WATER DISTRIBUTION SYSTEM

VIA CHRISTI ST. JOSEPH EMERGENCY DEPT. Ph. 2

3600 E. HARRY
 CITY OF WICHITA, KANSAS

AS-BUILTS	
Contractor:	Project Inspector:
Apex	Pablo Oden
Date: 2/11/2026

LINE 1

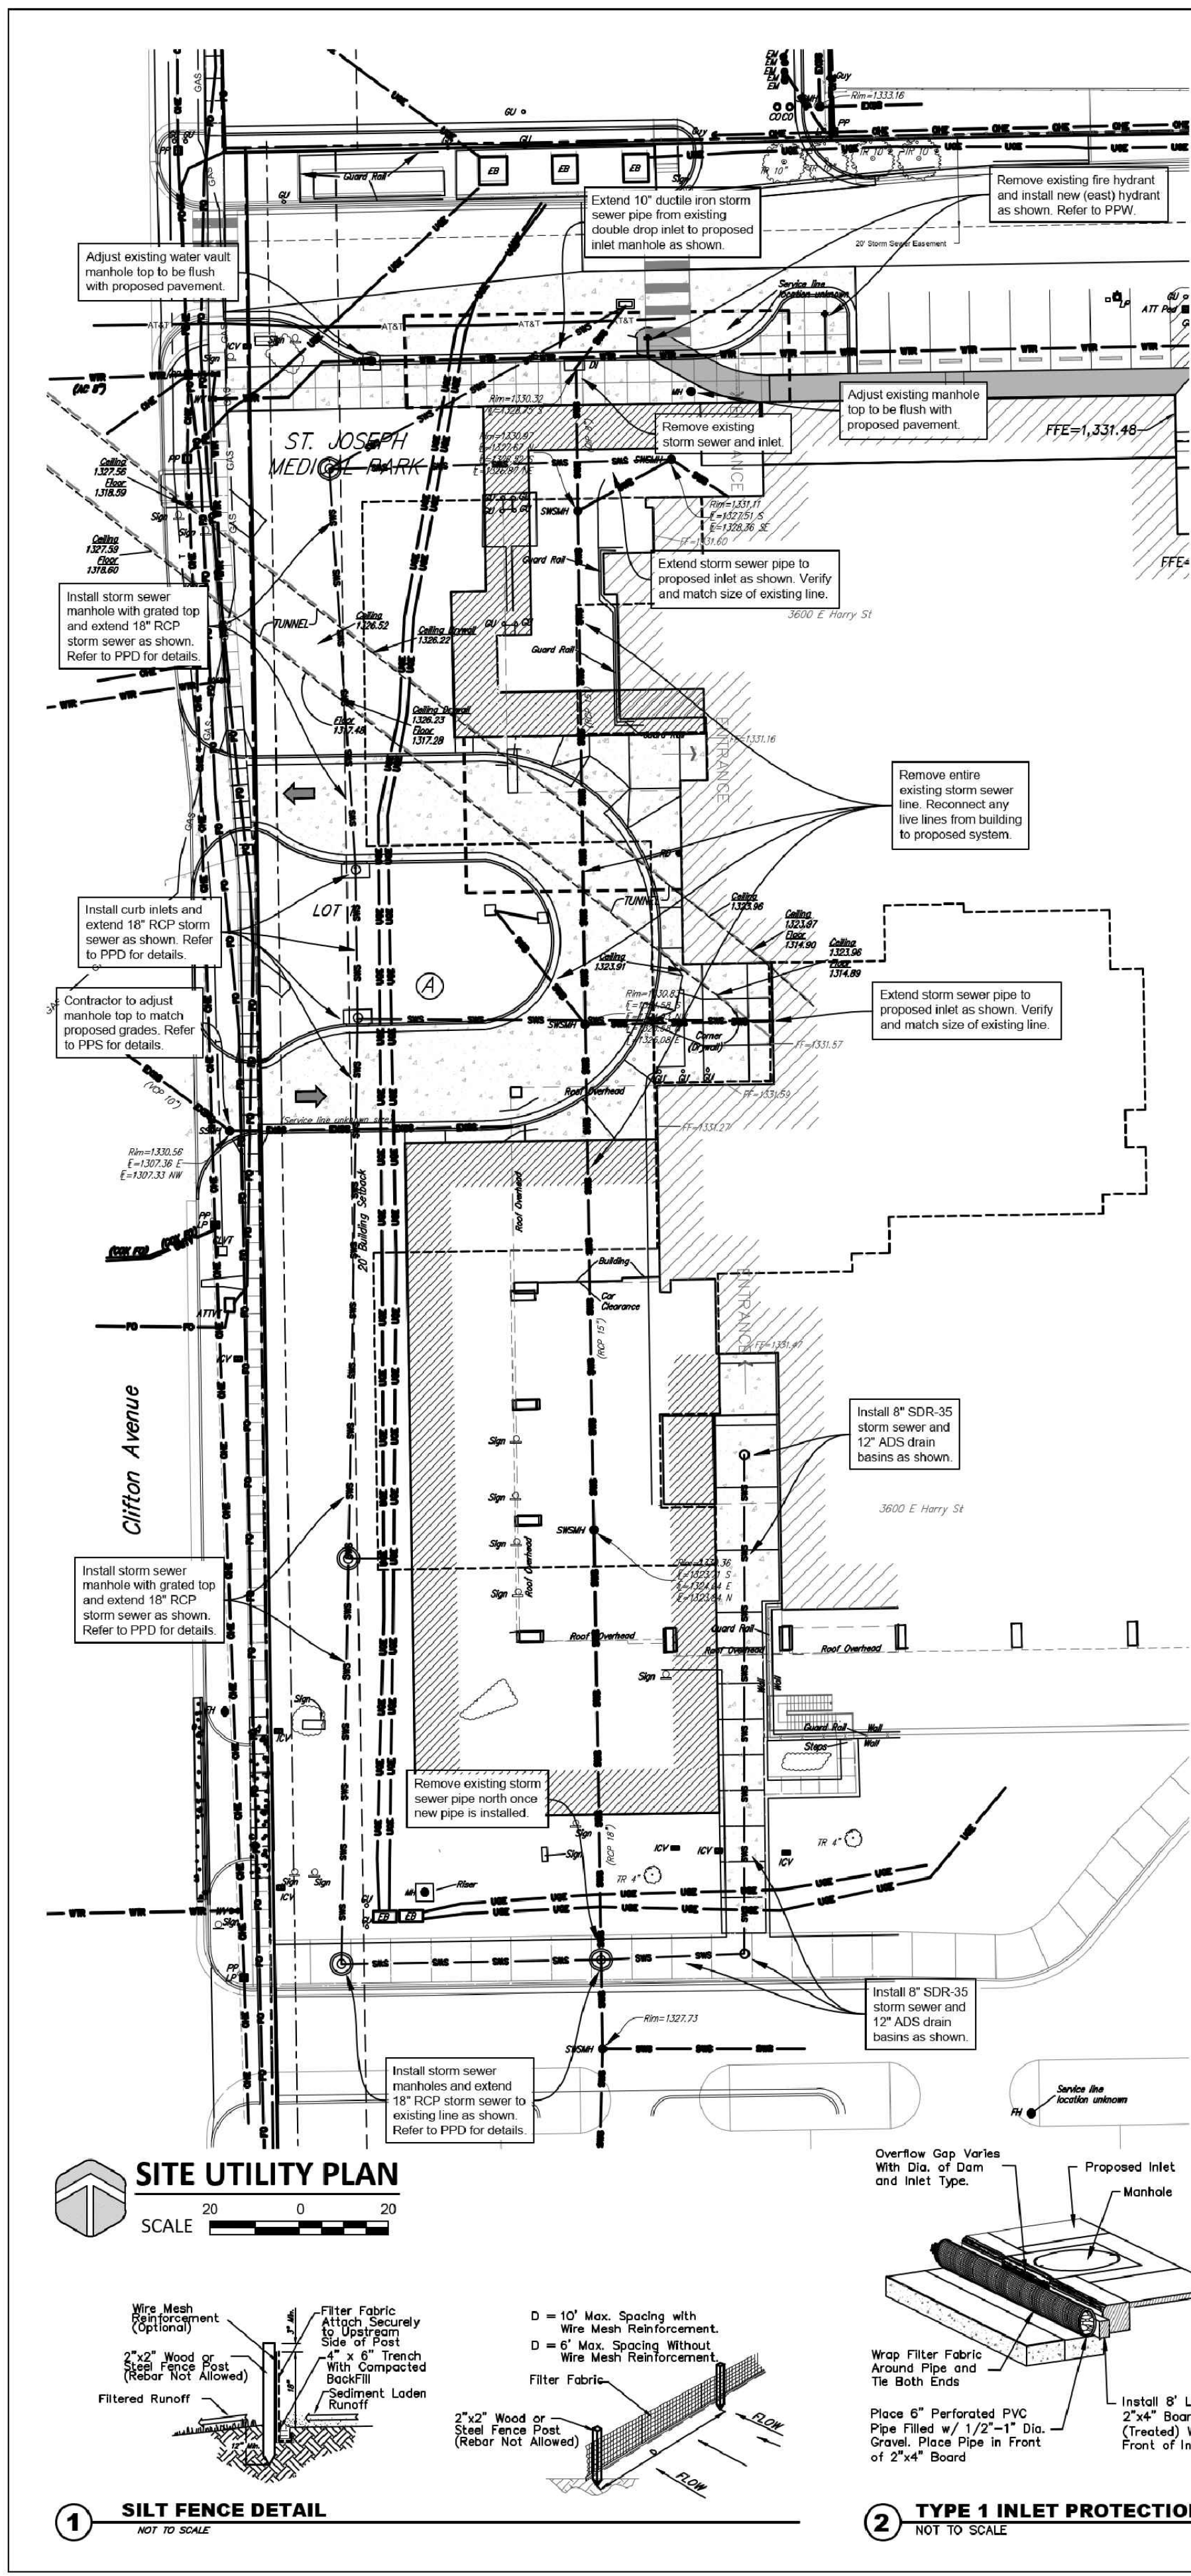
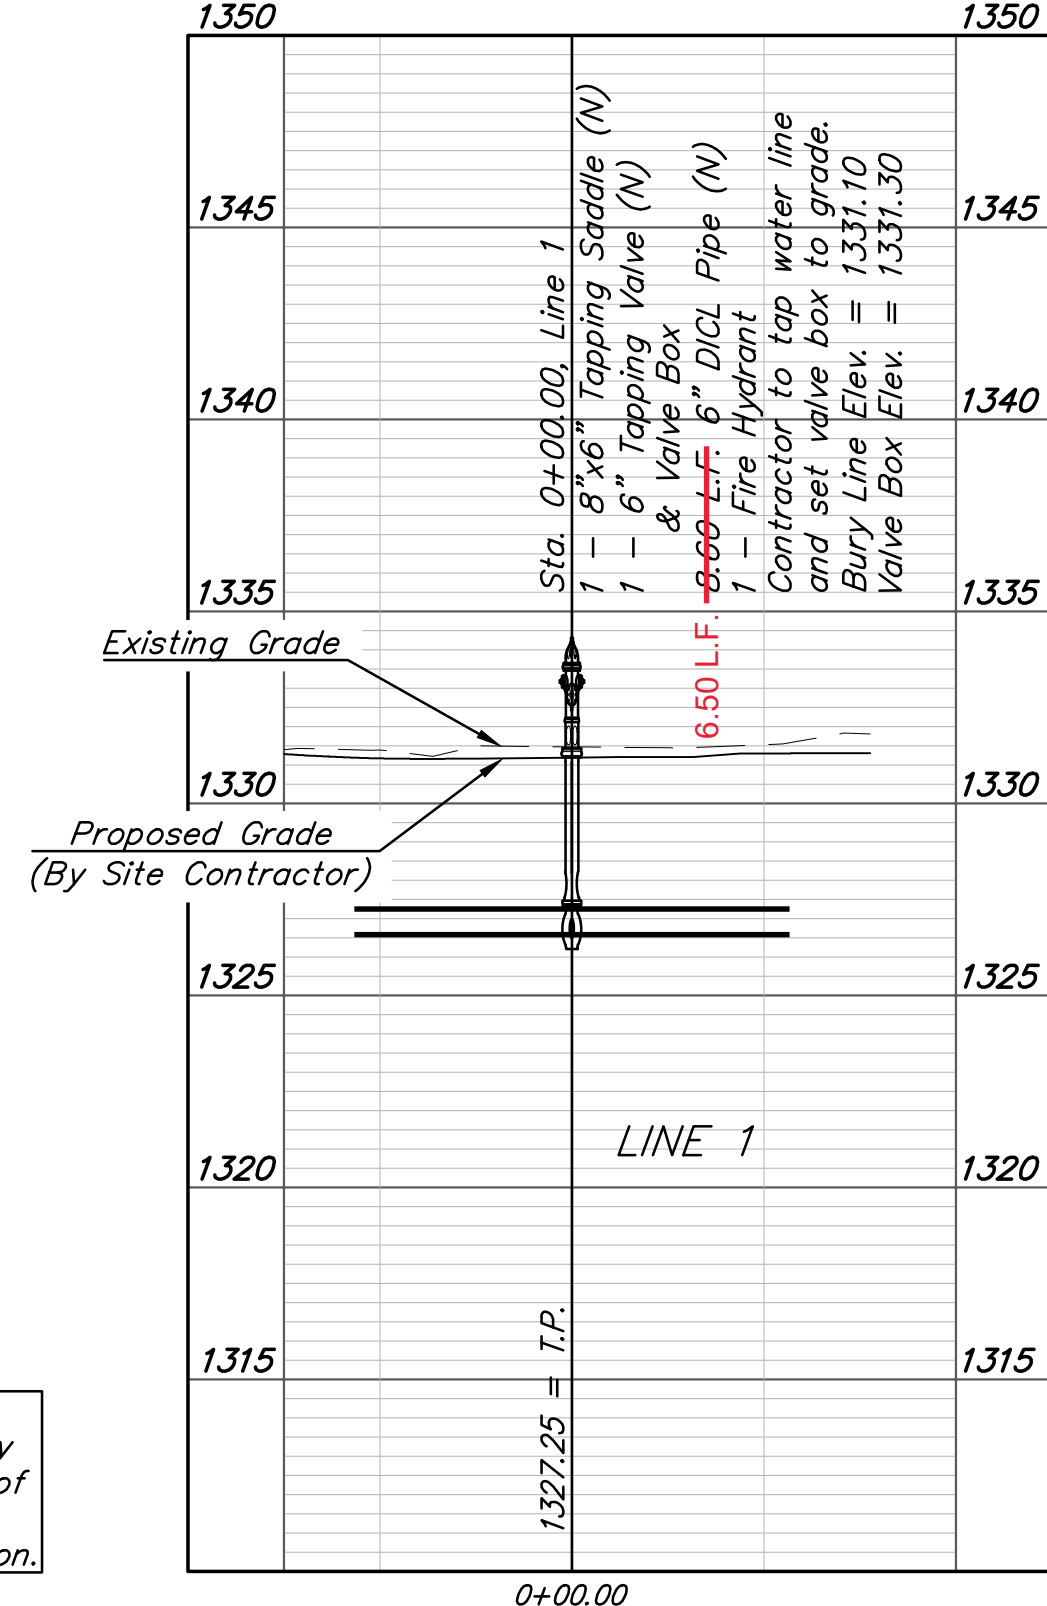
Contractor to verify whether the system is looped. If looped, bring south detector check valve up to City specs.

Single detector check valve to be replaced by double detector check valve per City specifications. Notify Jonathon Wheeler when completing this work 316-219-8917.

Installed 4.5" steel plate for thrust block installment

The original vault was large enough to accommodate the double detector check valve replacement. The existing vault could not be removed and replaced because nearby footing and utilities were in the way. Therefore, Beran Concrete poured a new concrete lid and reused the existing frame and lid components from the old concrete lid. The existing bypass meter and ERT were also reused. While also, chain and padlock were added to secure the new double detector assembly. Installation was confirmed by the GC (McCownGordon).
